Docket No. 50-346
License No. NPF-3
Serial No. 913
February 22, 1983

- I. Changes to Davis-Besse Nuclear Power Station Unit 1, Appendix A Technical Specifications 3.3.2.3, 4.3.2.3, Tables 3.3-15, 4.3-15 and Bases.
 - A. Time required to Implement. This change is to be effective upon NRC approval.
 - B. Reason for Change (Facility Change Request 79-283, Rev. B, Supp 3). This amendment request supercedes Toledo Edison submittal of November 15, 1982 (Serial No. 873) and responds to Generic Letter 82-16
 - C. Safety Evaluation (See Attached)

I. Changes to Davis-Besse Nuclear Power Station Unit 1, Appendix A
Technical Specifications 3.1.2.8, 3.1.2.9, 4.1.2.1 and 4.1.2.2.

I. Changes to Davis-Besse Nuclear Power Station Unit 1, Appendix A
Technical Specifications 6.9.1.4.

FIGURE - 1

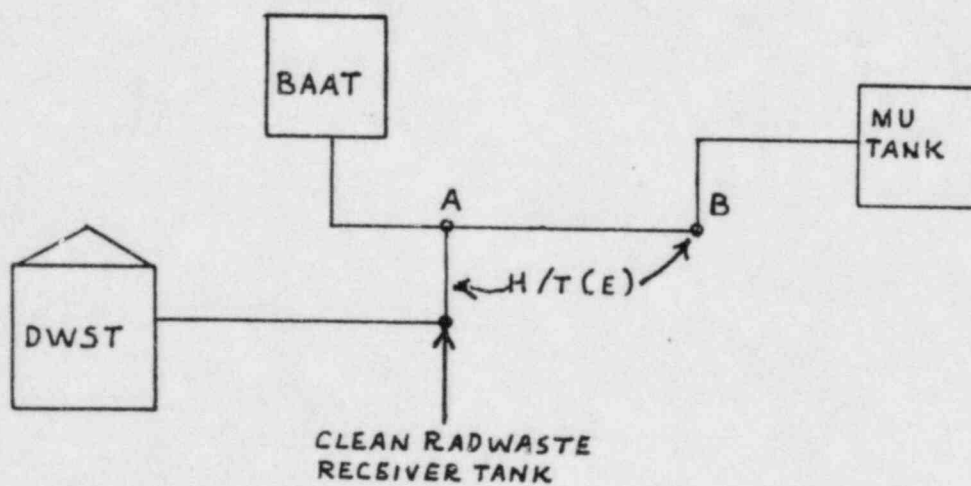
A section of the heat traced piping from the Boric Acid Addition Tank (BAAT) to the "T" connections to the letdown return line is used not only for Boric Acid addition from the BAAT but also is used for the transport of demineralized water and low boron concentration liquid (<5000 ppm) from the clean radwaste receiver tank. When this section of the piping is used for concentration of liquids of less than 5000 ppm boron, the maintainance of piping temperature greater than 105°F is not necessary.

Technical Specifications 4.1.2.1a and 4.1.2.2a should be revised because a section of the heat traced piping from the Boric Acid Addition Tank (BAAT) to the "T" connection to the letdown return line is used not only for boric acid addition from BAAT but also for the transport of demineralized water and other low boron concentration liquid (<5000 ppm) e.g. the clean radwaste receiver tank (see attached Figure 1). The only time that this temperature should be monitored above 105°F is determined by the attached decision tree. The decision tree demonstrates that the only time the need for temperature verification exists is during and after the flow path has been used for transporting fluid with a source concentration of >5000 ppmB. If at any time the line is used for transporting the fluid of source concentration <5000 ppmB the temperature need not be maintained above 105°F. During times when the line is used for transporting a boric acid solution more than 5000 ppmB and after that, the temperature needs to be verified to be more than 105°F. If the fluid source concentration is less than 5000 ppmB, the temperature need not be maintained above 105°F since per the attached graph (Figure 2) the crystallization will occur only below the freezing point of approximately 32°F. Thus, there is no safety concern for boric acid crystallization under those circumstances. Only when the flow path contains high (>5000 ppmB) boric acid concentration does the need for avoiding crystallization exist. Liquid samples are taken from the source for verification of boron concentration (not from the flow path) and this is so reflected in the revised Technical Specifications.

- a. At least once per 7 days by verifying that the pipe temperature of the heat traced portion of the flow path is $\geq 105^{\circ}\text{F}$. THIS IS APPLICABLE DURING
~~when a flow path from the concentrated boric acid storage~~
~~system is used, and AFTER THIS FLOWPATH IS USED TO TRANSPORT BORIC ACID SOLUTIONS WITH A~~
~~FLUID SOURCE CONCENTRATION MORE THAN 5000 PPM B UNTIL THE TIME THAT THIS FLOW PATH IS USED FOR~~
- b. At least once per 31 days by verifying that each valve (manual, ANY OTHER PURPOSE.
power operated or automatic) in the flow path that is not locked, sealed or otherwise secured in position is in its correct position.

- a. At least once per 7 days by verifying that the pipe temperature of the heat traced portion of the flow path from the concentrated boric acid storage system is $\geq 105^\circ\text{F}$ ^{THIS IS} ~~APPLICABLE~~
DURING AND AFTER THIS FLOW PATH IS USED TO TRANSPORT BORIC ACID SOLUTIONS WITH A FLUID SOURCE CONCENTRATION MORE THAN 5000 PPM B UNTIL THE TIME THAT THIS FLOW PATH IS USED FOR ANY OTHER PURPOSE.

FIGURE-2

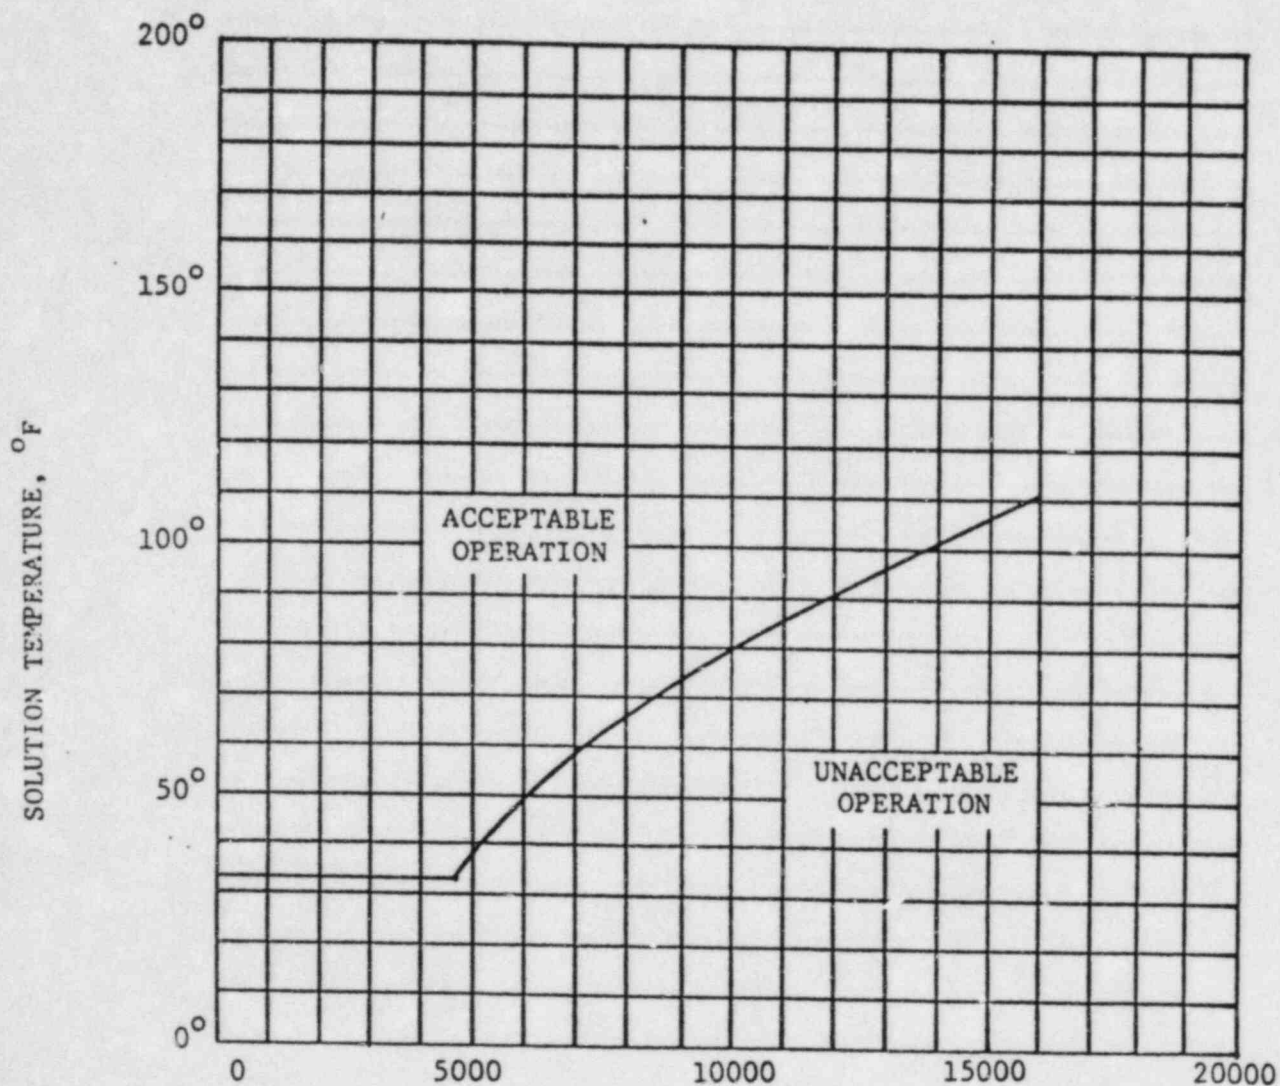
Technical Specifications 3.1.2.8a.3 and 3.1.2.9a.3 require that the boric acid addition system and associated heat tracing have a minimum solution temperature of 105°F. However, revised Technical Specifications 4.1.2.1a and 4.1.2.2a will ensure that the associated heat traced portion of the flow path from the concentrated boric acid storage system is > 105°F when this flow path is used to transport boric acid solutions with a fluid source concentration more than 5000 ppmB until the time that this flow path is used for any other purpose. Therefore, Technical Specifications 3.1.2.8a.3 and 3.1.2.9a.3 should not include the associated heat traced portion since the Surveillance Requirements for its operability are already included in revised Technical Specifications 4.1.2.1a and 4.1.2.2a.
